City of Hastings

Planning Commission Memorandum

To: Planning Commission Members
From: Justin Fortney, Associate Planner
Date: June 11, 2012
Item: **Tabled** - Site Plan Review – Hastings Chrysler Rapid Lube carwash addition #2012-25 –2980 Highway 61.

Drawing:
EXTERIOR
ELEVATIONS

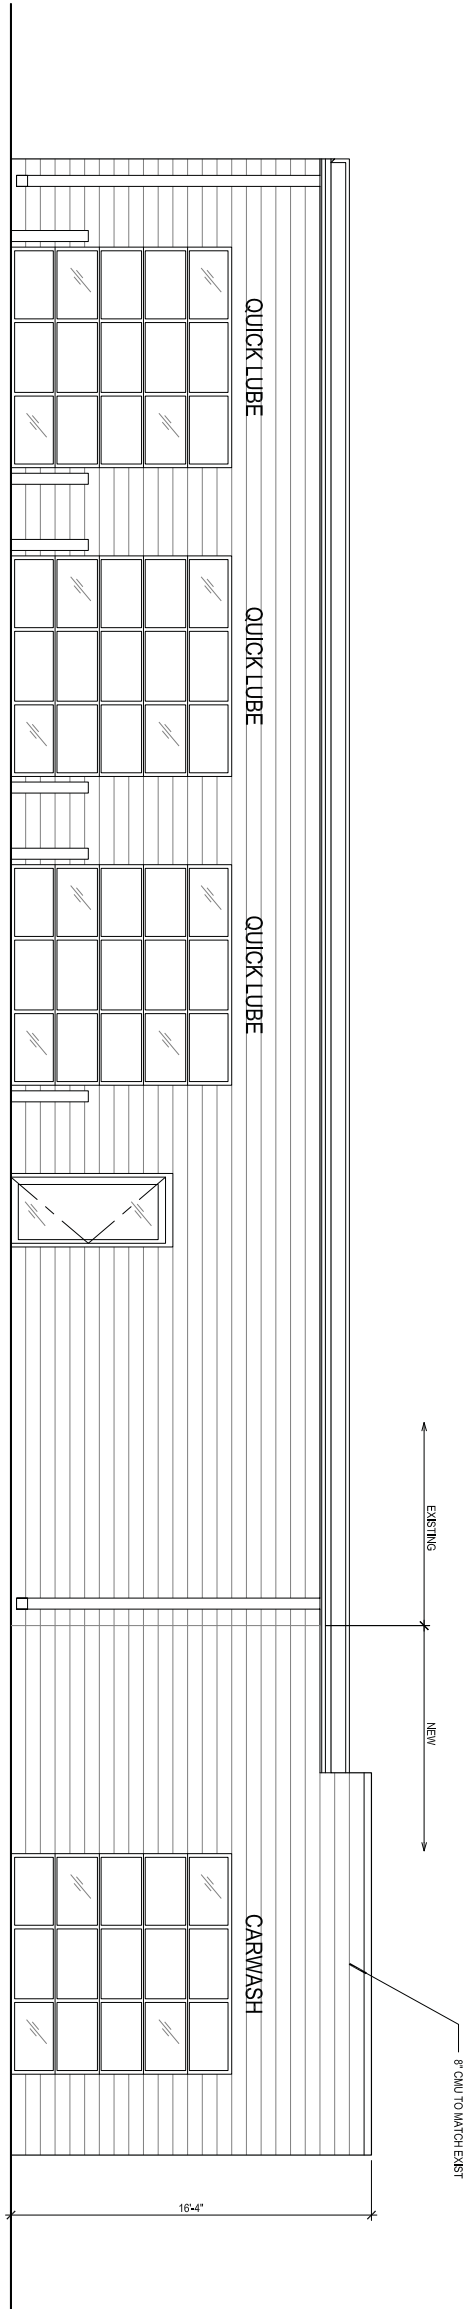
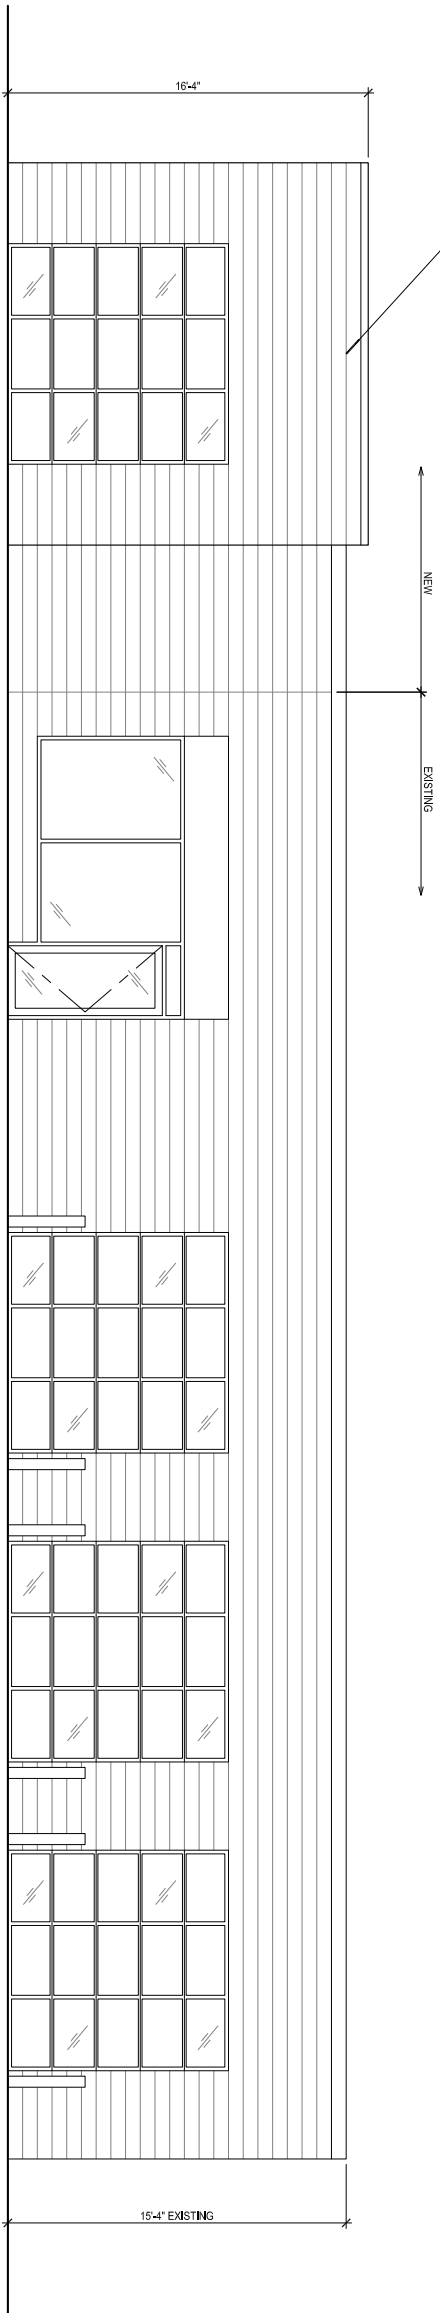
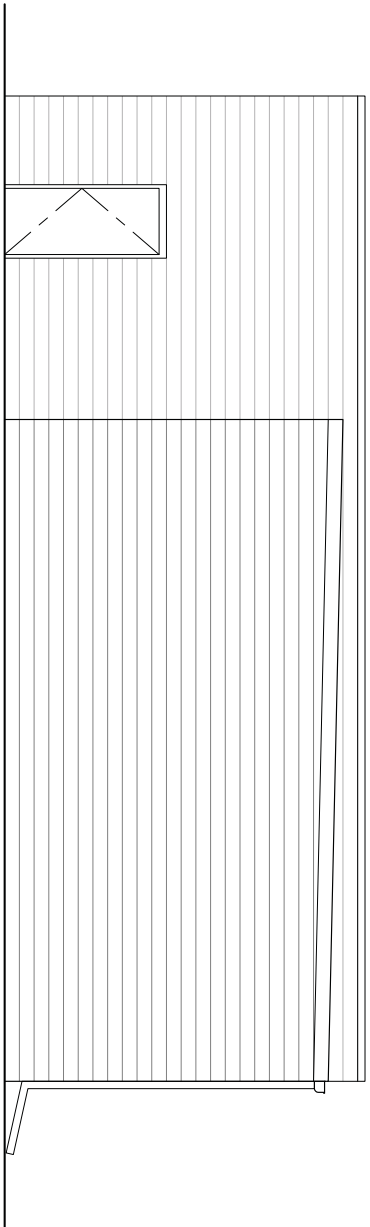
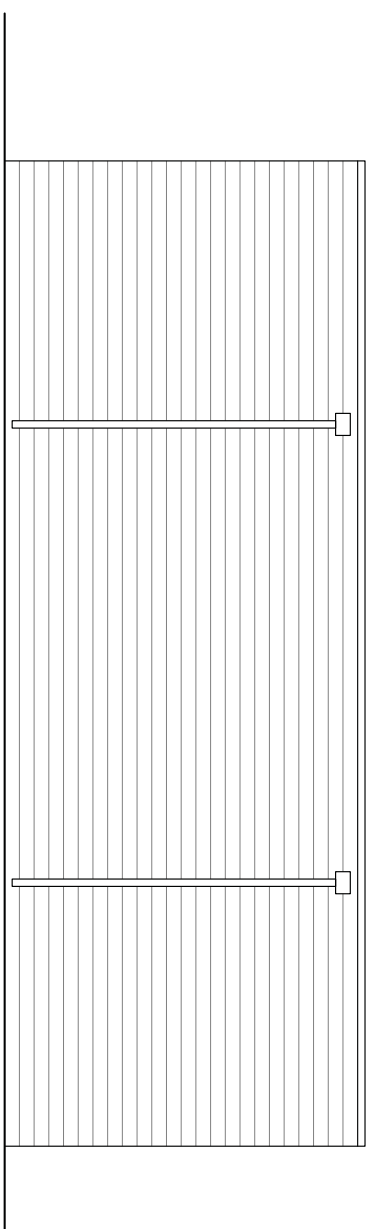
The proposed materials are the same as the existing building, painted CMU (concrete masonry unit). With having glass doors, the building would meet the 25% class one requirement of the design guidelines, but the concrete blocks making up the rest of the building would be considered class 3. This would leave the 75% class 2 requirement unfulfilled (CMUs only meet class 2 standards if they have integrated color, rather than are painted). Since this is a small addition, materials similar to existing are sufficient.
